**Service info**

Unit type: Chassis TV 17.xx

Unit type                    :Chassis TV 17

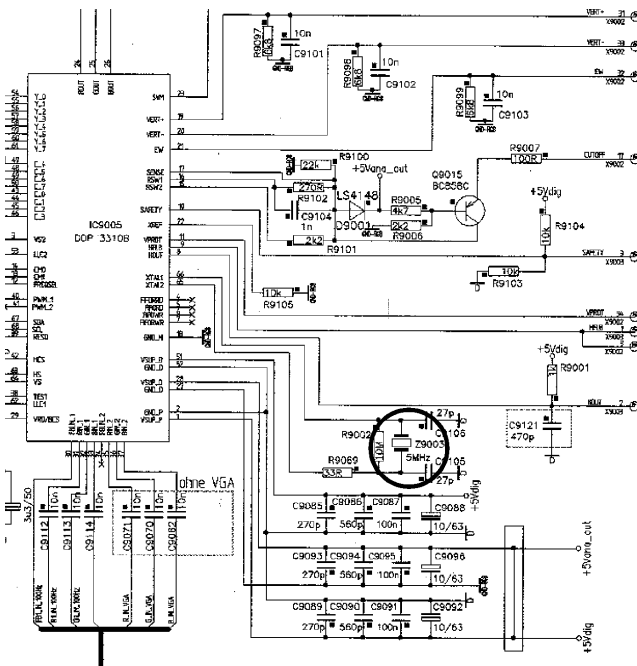
**Concern:** - Failure of the horizontal output amplifier ( Q 307 / 2 SC 5129 )  
 - The set don't start up

**Remedy:** - The 5Mhz crystal in position Z9003 has to be removed and replaced by the below declared replacement version.  
 - The below declared silicon foil has to be applied between the crystal and the board.

Part no. crystal 5Mhz:      0053707  
 Part no. silicon foil:      0109059

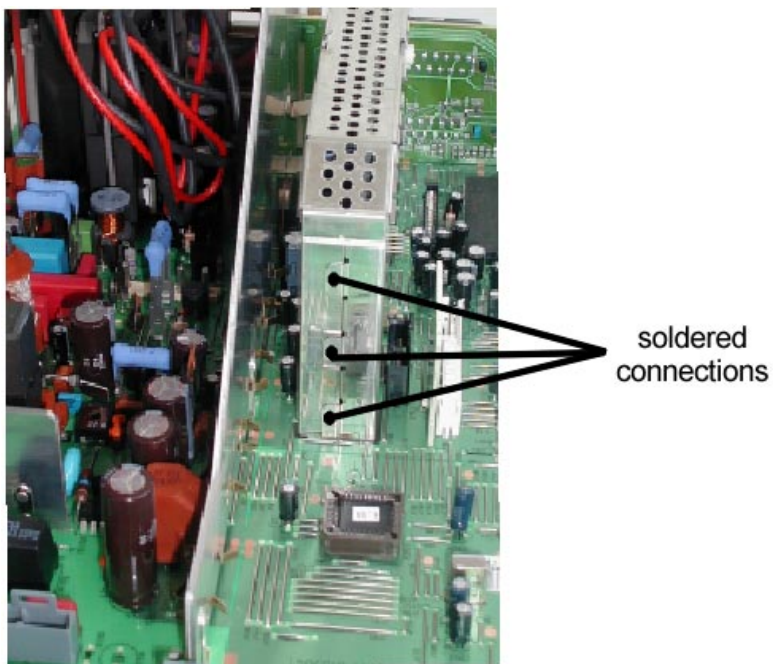
**Concern:**      Stripes at the left side of the screen

**Remedy:**      To eliminate the stripes at the left side of the screen the both parts of the sheet-metal case have to be connected ( soldered ) at both front sides a like the illustration.

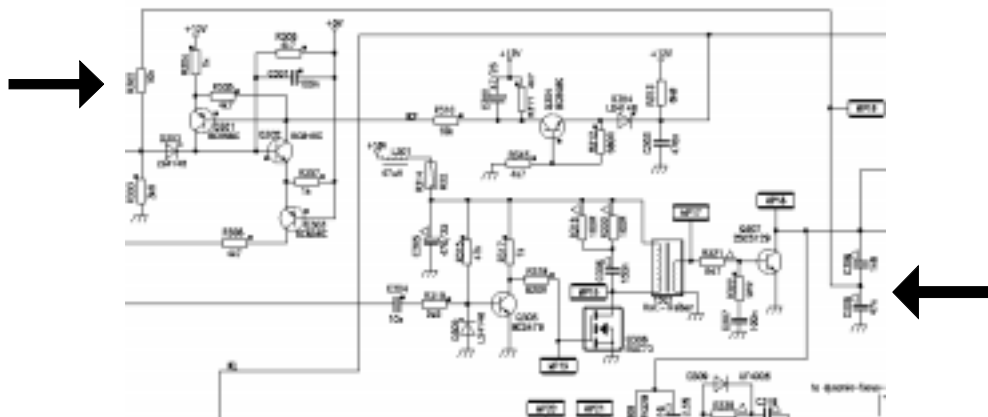
**Concern:** Improvement of the reliability.

**Remedy:** To improve the reliability the capacitor in position C 309 has to be removed and replaced by a replacement version. Additional the resistor in position R 302 has to be observed and if necessary to be replaced.

Spare part number capacitor : 0109091  
Spare part number resistor : 0031134

1. Feature-Box version 1:

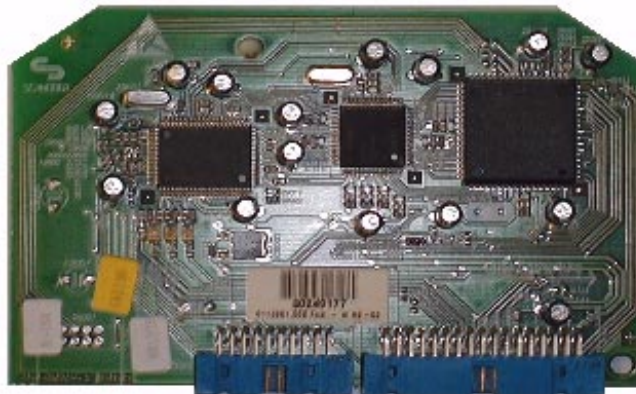
- The main recognisable distinguishing mark between the feature box versions is the number of the integrated IC's ( version 1: four pieces / version 2: three pieces).
- In case that the feature box version 2 is integrated the software version X 4.5x or Y 4.5x has to be used.
- Each TV 17 board have got an identification sticker ( see below sketch ). In case of an integrated feature box version 2 the chassis identification number starts with the figures " 011... ".

**Sketch 1:** front side cabinet inside view

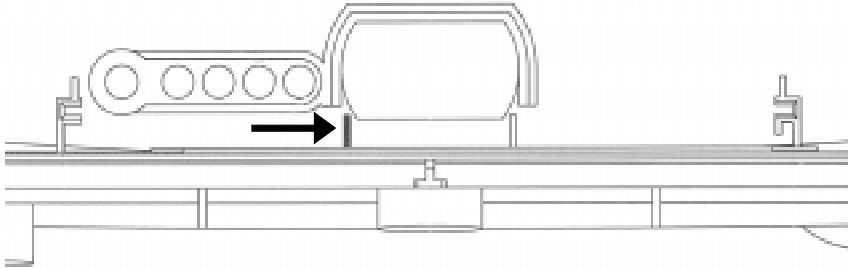
- ① Jamming push button of the main power main power switch
- ② Stby LED without function

① To avoid the jamming of the push button, the plastic rip at the left side, below the push button aperture has to be removed alike sketch 1.

**Sketch 2:** Layout TV 17

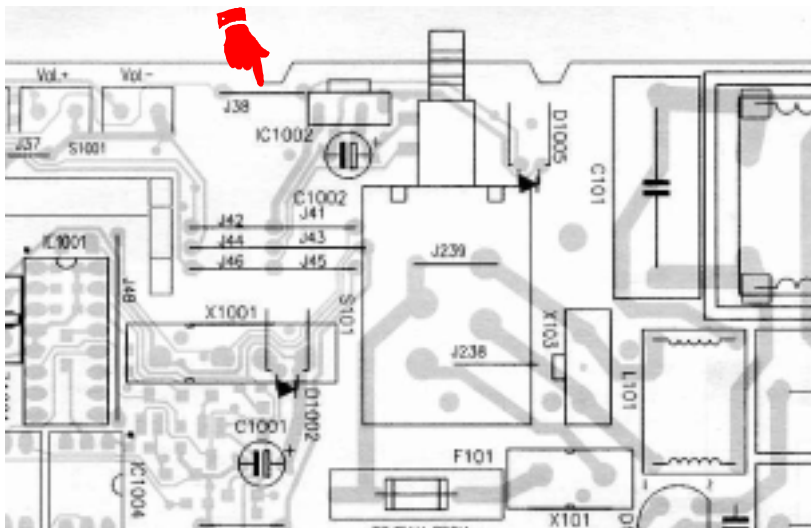
② The soldering pin of the jumper „J38“ may be damaged by a plastic rip (sketch.2). As a result of this the stand-by LED is without function. To avoid this the left plastic rip below the push button aperture has to be removed alike sketch 1.
